75W MODIFICATION TO APPLICATION TO  
BARANGAROO CONCEPT PLAN (MP06\_0162 MOD 8)

## MOD 8 DRAFT CONDITIONS | PART B – MODIFICATIONS TO CONCEPT PLAN **RESPONSE TO CONDITION B3**

16 FEBRUARY 2016

*West Elevation*

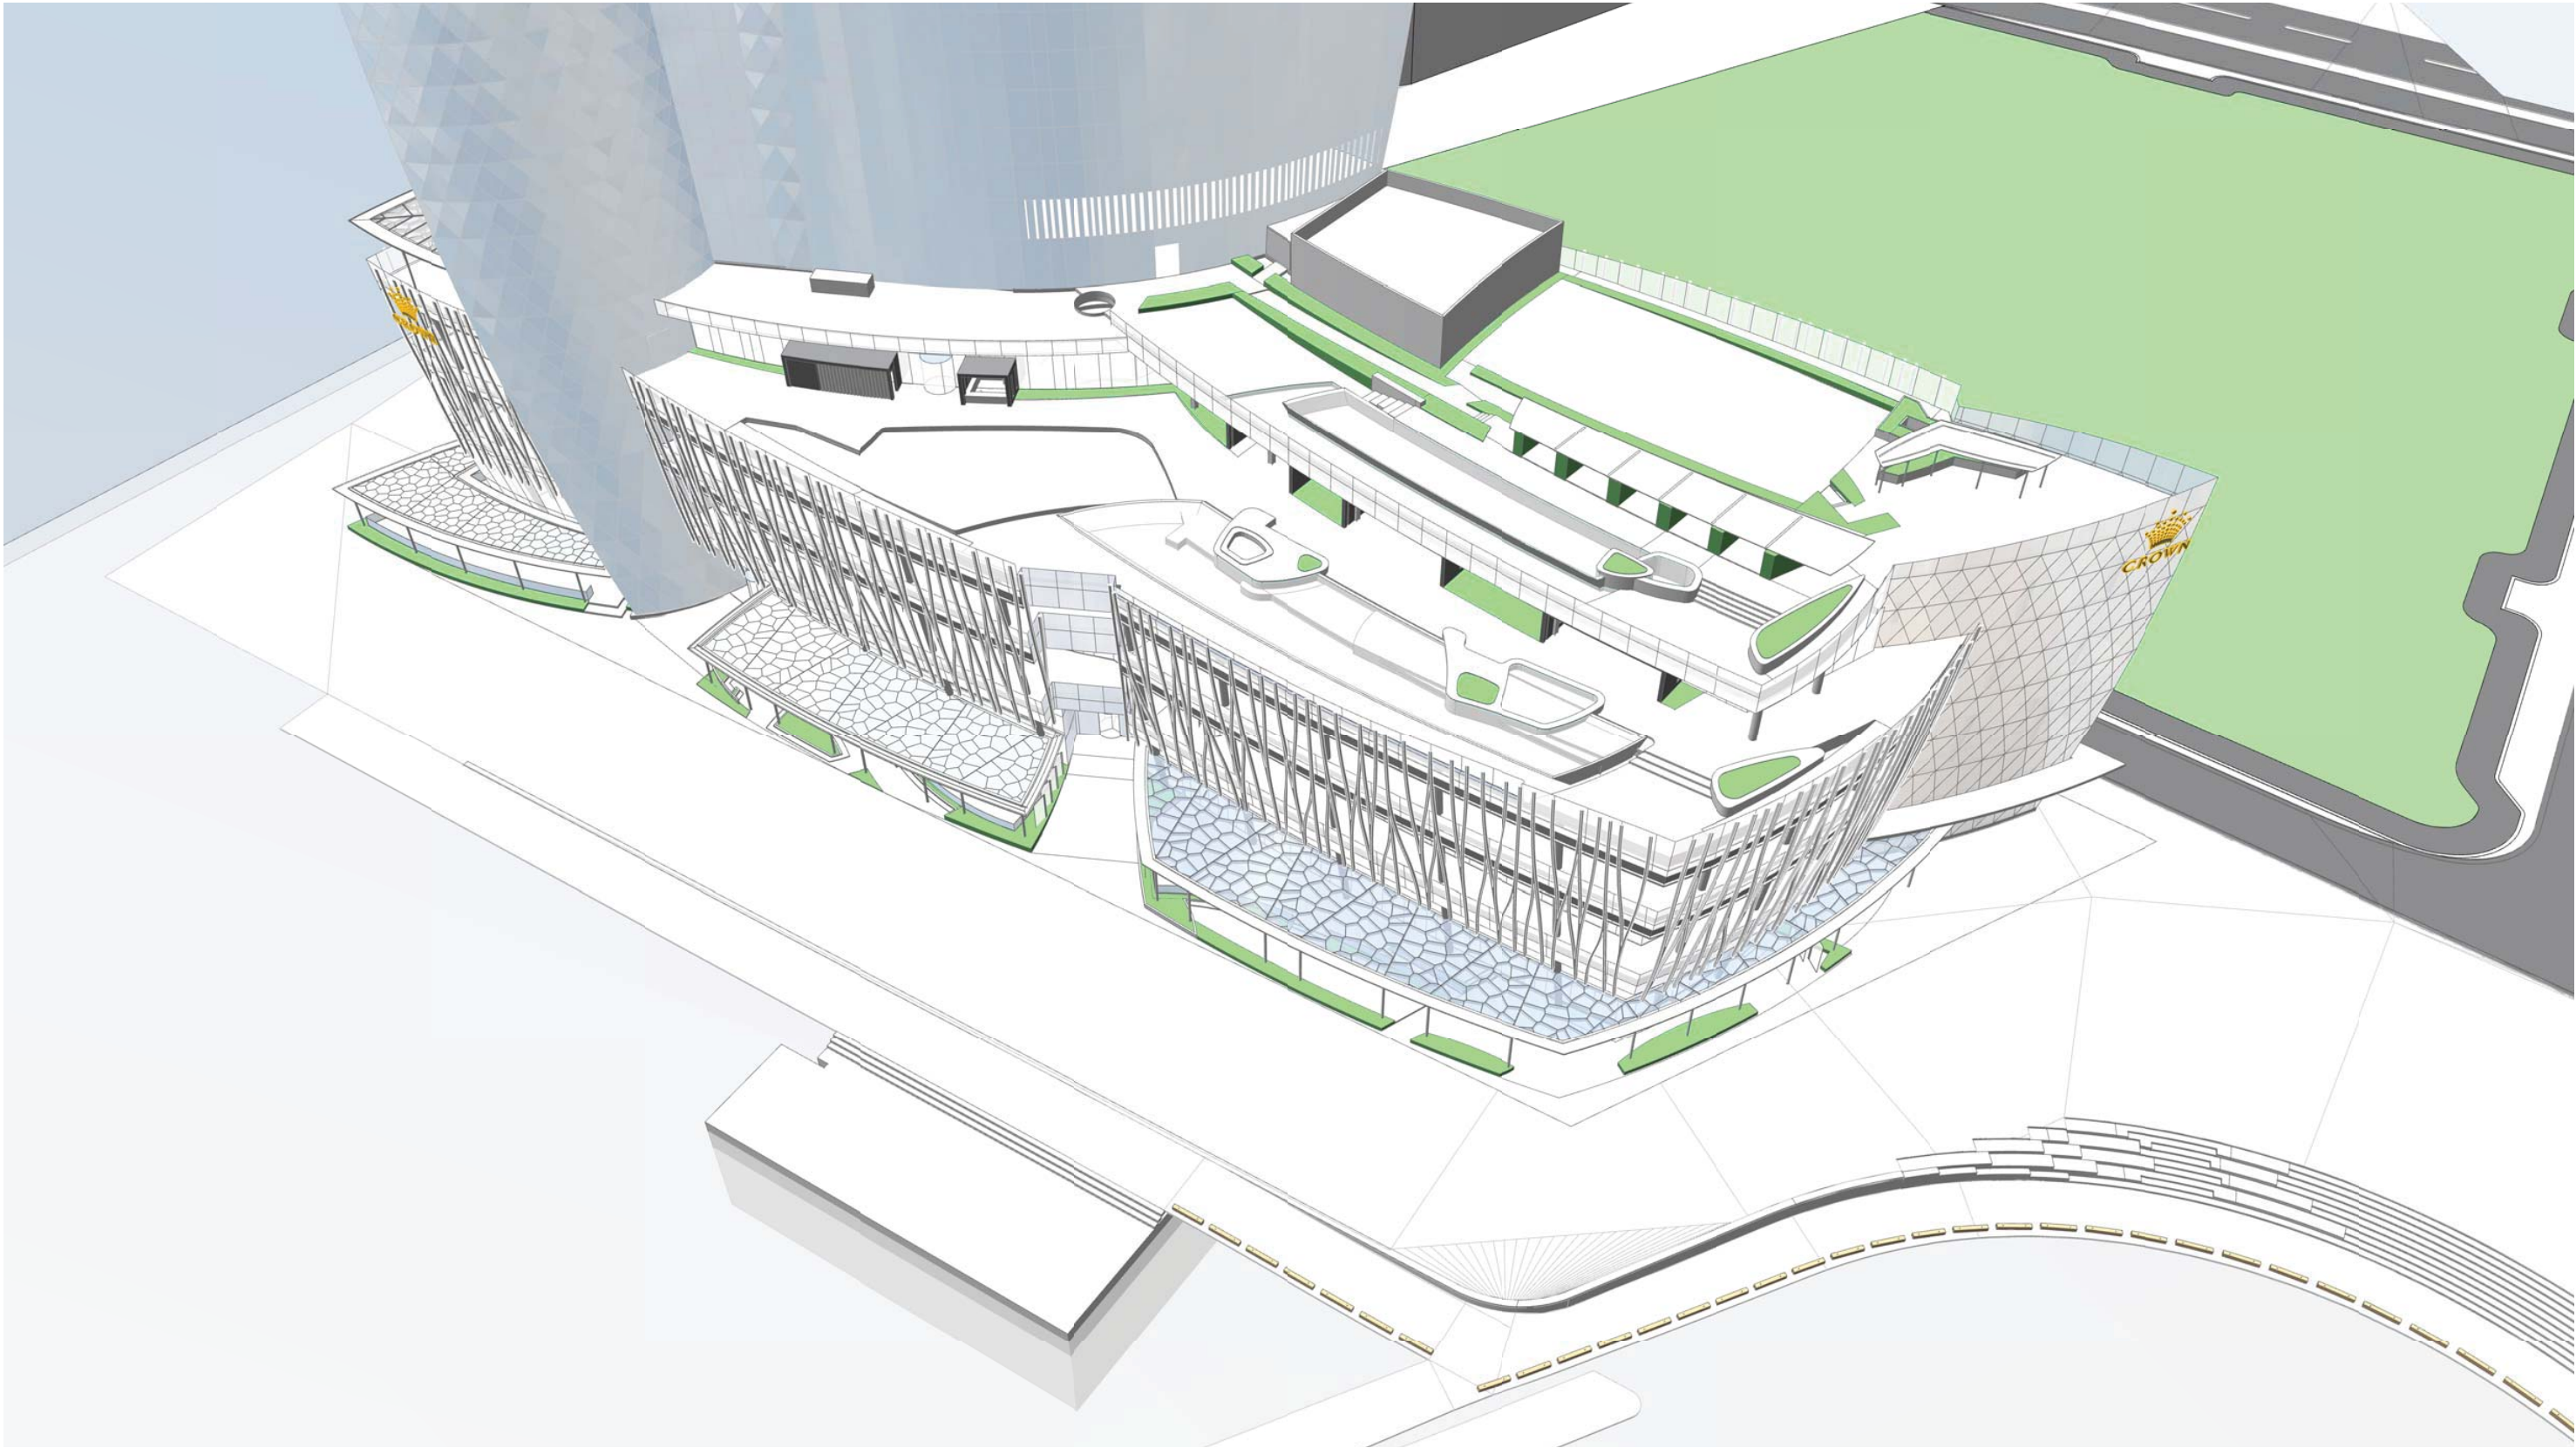
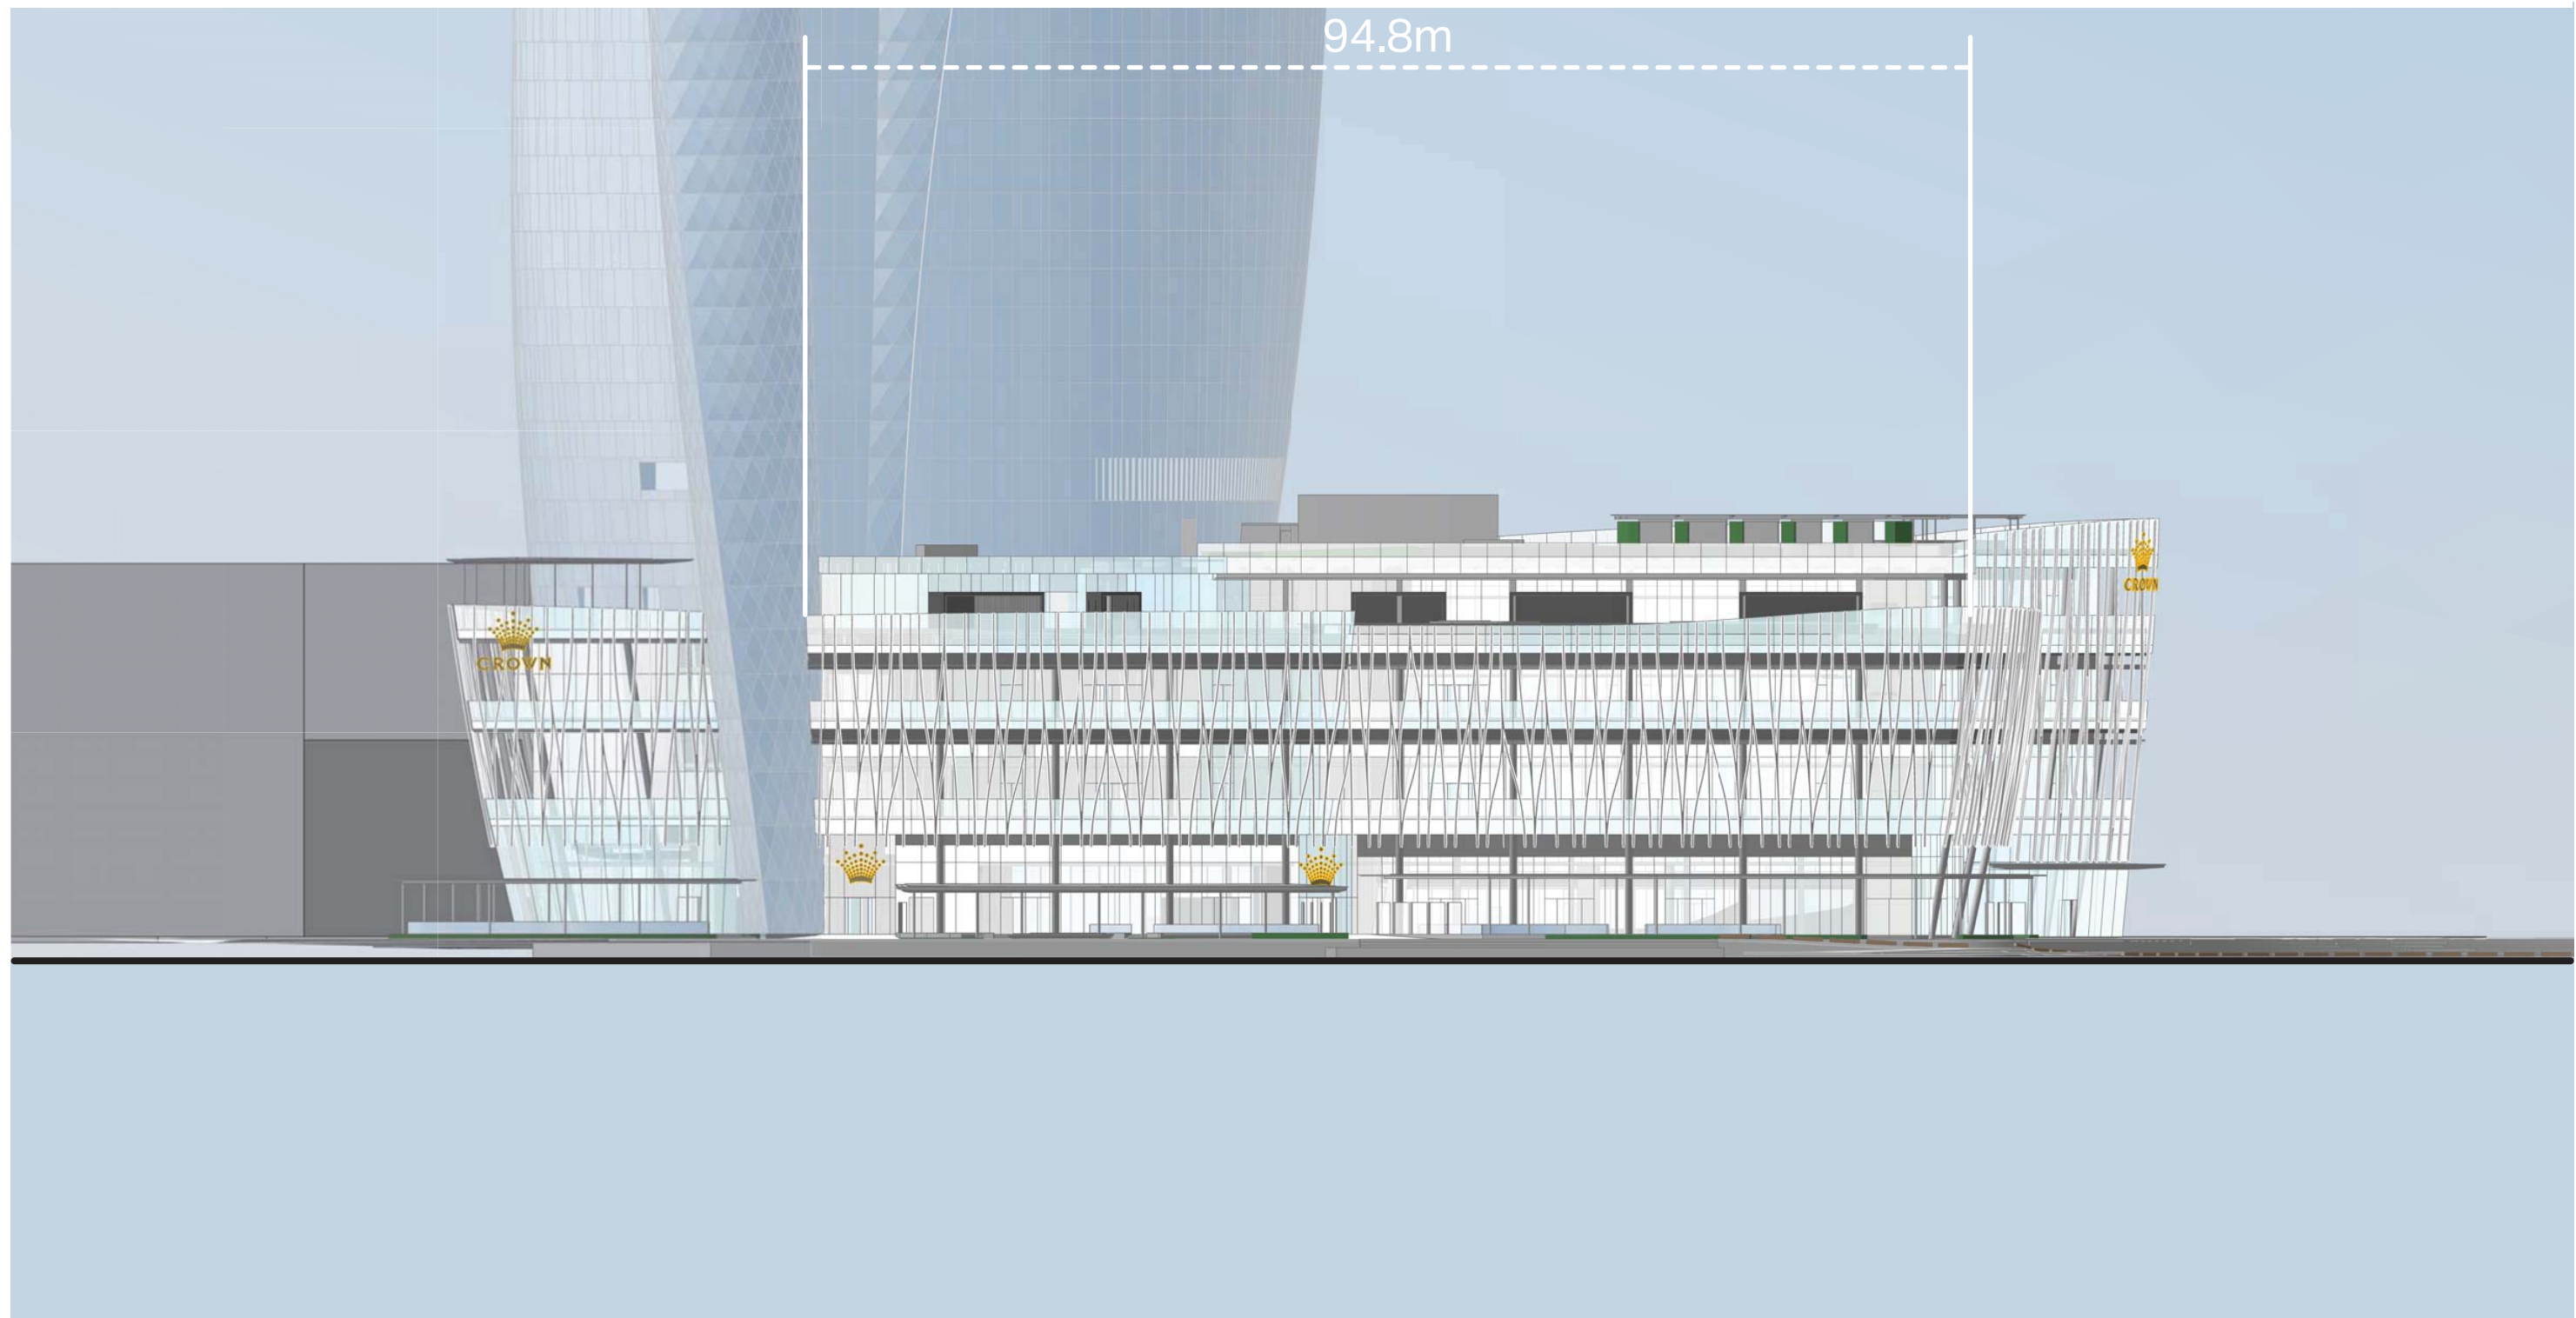
As illustrated within the attached plans, the westerly facade of the CSHR podium has been re-designed in order to break the podium structure up into distinct building elements that are now viewed as a segmented building in lieu of a continuous built form.

By re-designing the podium facades in this manner, the overall perceived length of the façade is significantly reduced when viewed from the surrounding Public Domain and from across the harbour.

The stated objective of reducing the excessive length, bulk and scale of the podium is to ensure a more appropriate relationship to its foreshore context has, in our opinion, been achieved as the podium will no longer be viewed as a continuous, unbroken built form.
